April 1, 1996

Re: Relocation of Additional Extraction Wells
Groundwater Treatment Project - Lot 203
MCB Camp Lejeune - D.O. 0015
Contract N62470-93-D-3032

From: Dan Fisher
To: Bill Mullen/LANTDIV, Lance Laughmiller/LANTDIV
Subject: Well Location Justification

SITE PIPING PLAN

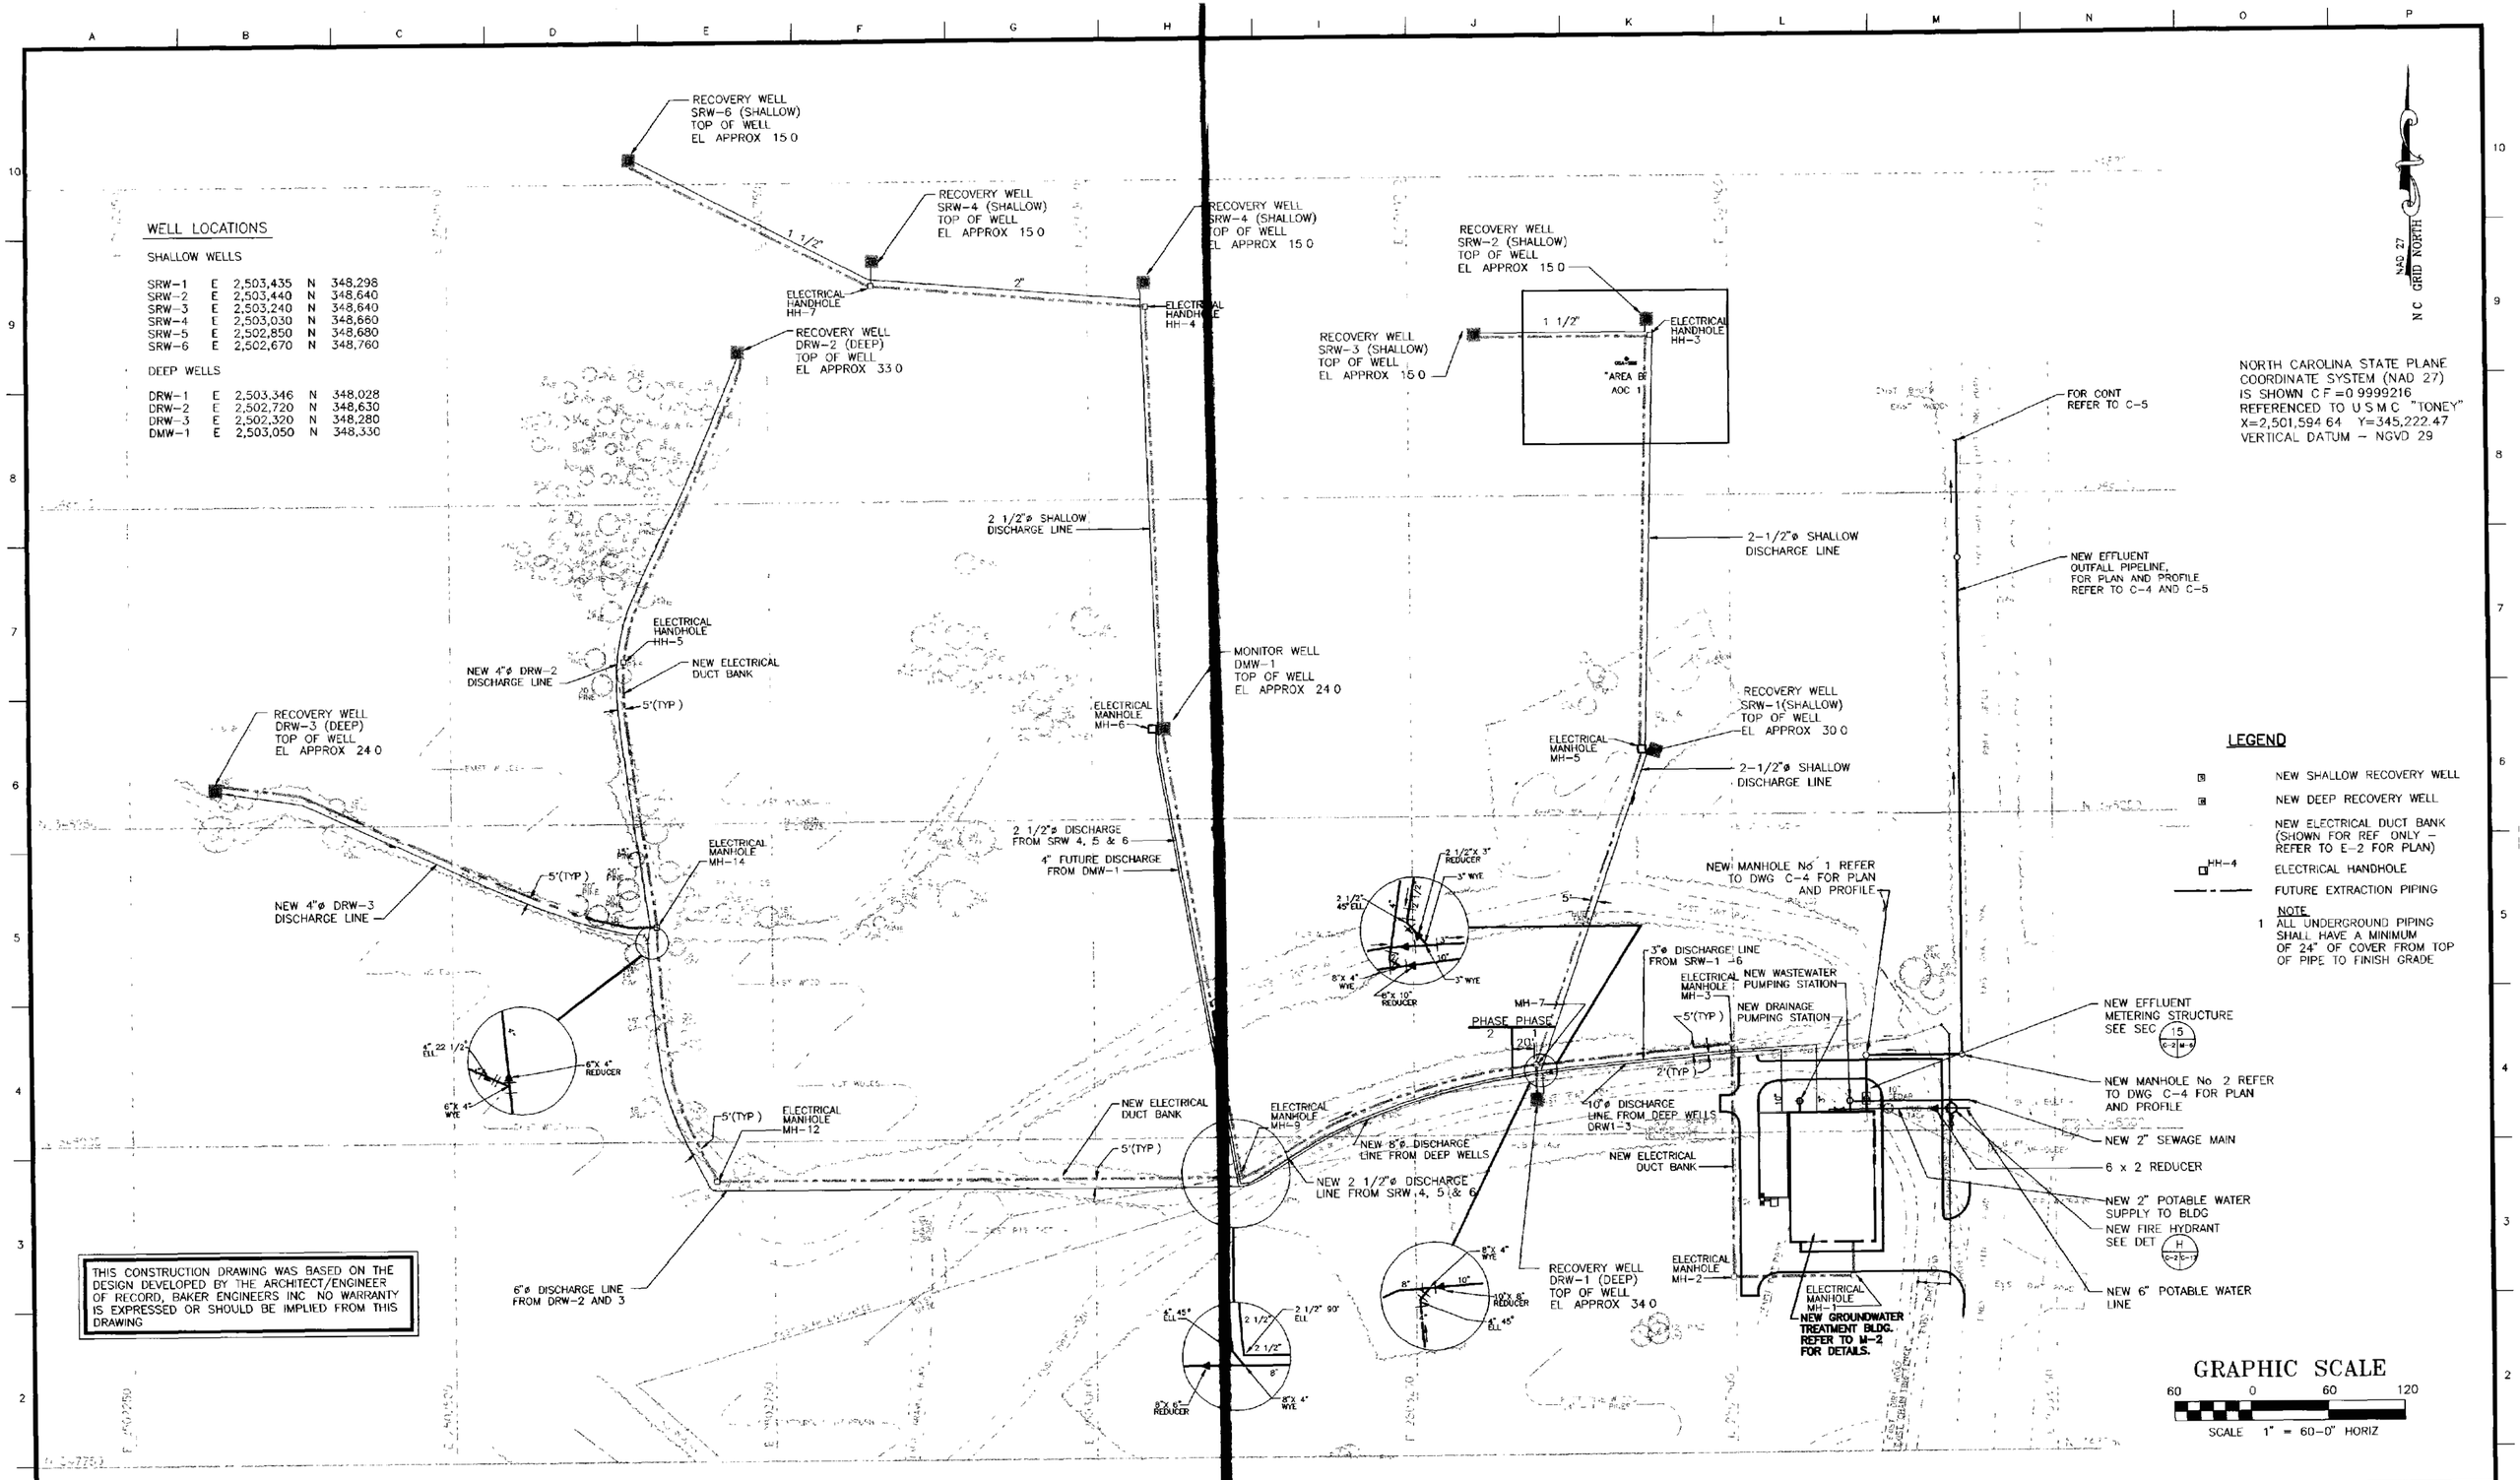
In Lance's absence, please find enclosed herewith a package of drawings which depict the revised locations for extraction wells and one proposed deep monitoring well for Site 82 at MCB Camp Lejeune, N.C. Baker Environmental has also provided a descriptive summary of how the results of the aquifer testing were used to determine the new well placements.

TYPICAL SECTION – DRW 1,2, AND 3 AND DMW-1

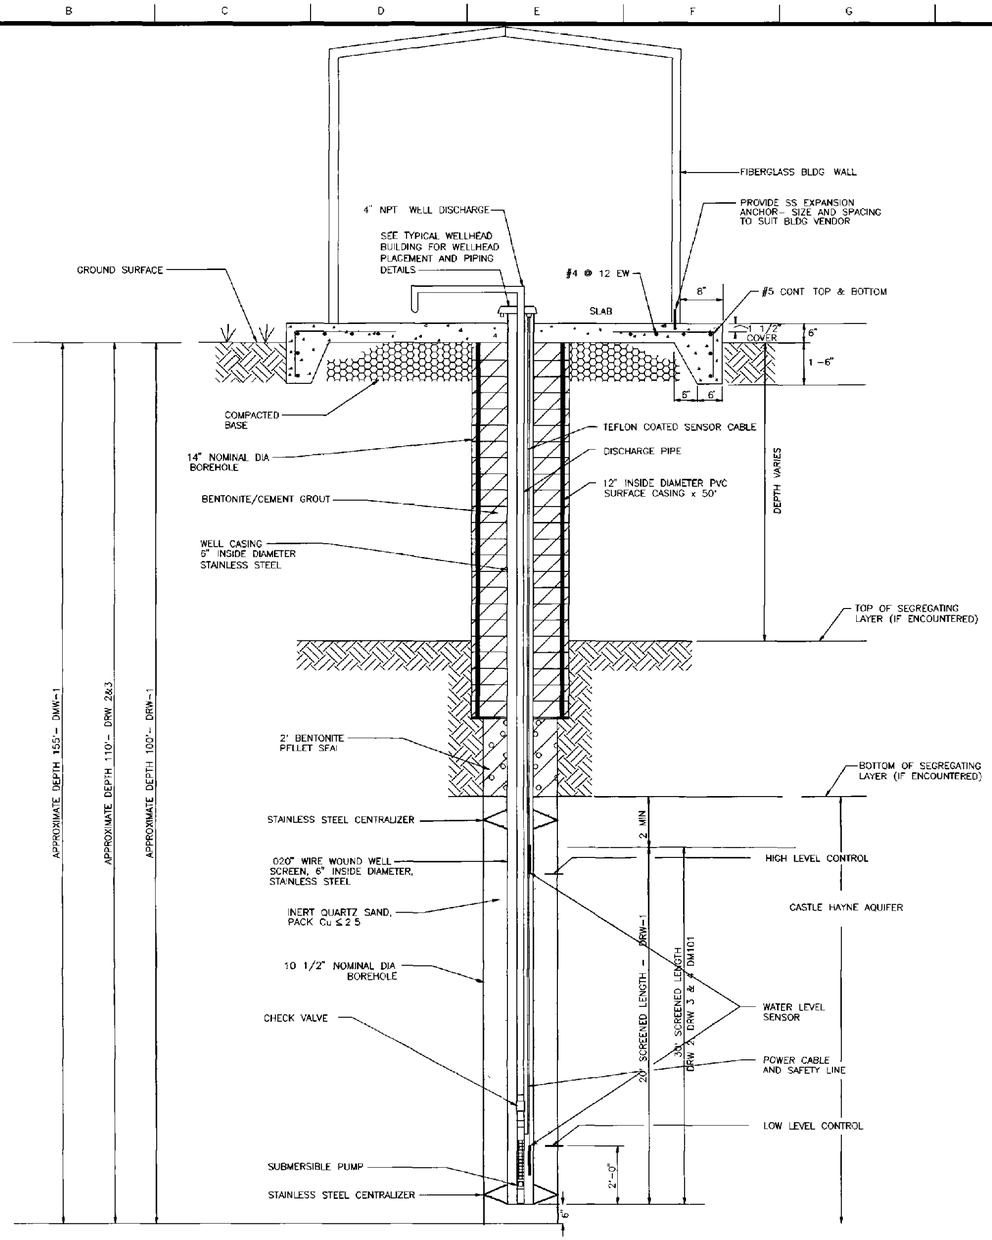
Well depths of the addtional wells were not changed radically from the existing wells: shallow wells about 30-35 feet bgs and deep wells 80 - 110 feet bgs. The depth of the shallow wells is based on the identified zones of contamination in the surficial water-bearing zone. Incidentally, a diameter of four inches is sufficient to produce 5 gpm in the shallow zone, rather than six inches as was installed in SRW-1.

The depth of the deep wells is in line with the prevailing notion of "not drawing contamination further downward," and while this is a desirable goal, it necessarily limits the available drawdown, and hence, the amount of water pumped by the system. The original estimates of deep well yield were based on the production of HP-651 (about 250 gpm), but the new extraction wells are screened shallower (80 to 110 feet bgs versus 125 to 300 bgs for HP-651) and are smaller in diameter (6 inch versus 10 inch) than the production well. The new estimates of pumping in the deep wells (40 gpm) are based largely on the real rate from DRW-1

The zone tapped by the former production well (125 to 155 feet bgs) will be monitored by DMW-1 to determine the level of contamination, if any, at that depth. It will also be used to evaluate the hydraulic effects of pumping the overlying depths.
